**Our Case Number:** ABP-322638-25

**Re:** Proposed residential development at the Kishoge Development area of Clonburris SDZ  
In the townlands of Kishoge, Esker South, Grange and Balgaddy, Clonburris, County Dublin

*Third Party planning observation in respect of a South Dublin County Council Section 175 of the planning and development act, 2000 (as amended) application to An Coimisiún Pleanála. The Observation pertains to An Coimisiún Pleanála planning application, reg. ref. JA06S.322638 (and South Dublin County Council reg. ref. SDZ25X/0001), which seeks approval to carry out development at lands cumulatively measuring c. 29.39 hectares, comprising three sites referred to as Site 3, Site 4, and Site 5, located predominantly within the Kishoge Development Area of Clonburris Strategic Development Zone (SDZ), in the townlands of Kishoge, Esker South, Grange, and Balgaddy, Clonburris, County Dublin. The proposed development at Sites 3, 4 and 5 broadly comprises the development of 1,252 no. residential units in a mix of houses, duplexes, triplexes and apartments; 2 no. childcare facilities; 1 no. community building; retail uses; refurbishment works to Grange House for future reuse.

Fig. 8: Existing two storey character of Tullyhall rise

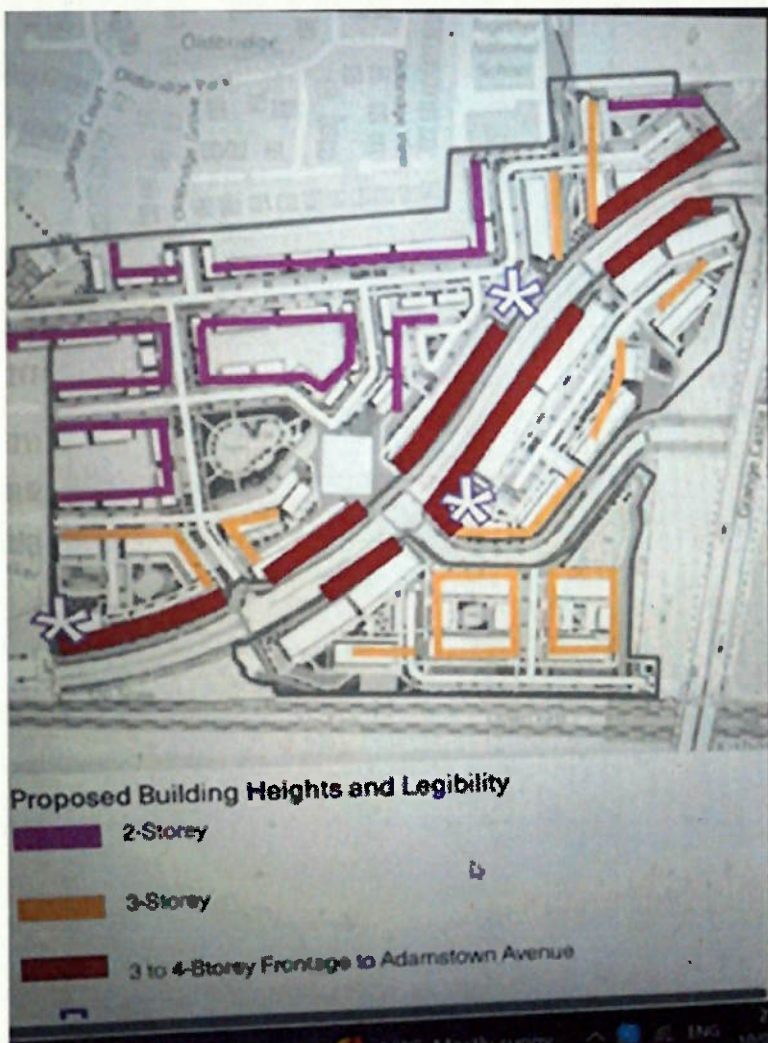
The TRA is, like Sinn Fein, opposed to any development directly beside existing houses other than those that should be of the same height and at same ground level. The plans make specific reference to 3 story buildings and a 5 story apartment to be built directly beside Tullyhall Rise & Drive (see Fig. 9).

- SDCC should carry out further consultation before altering estate boundaries.
- Revised drawings are required showing building heights rising in a staggered manner from Tullyhall and eastward.
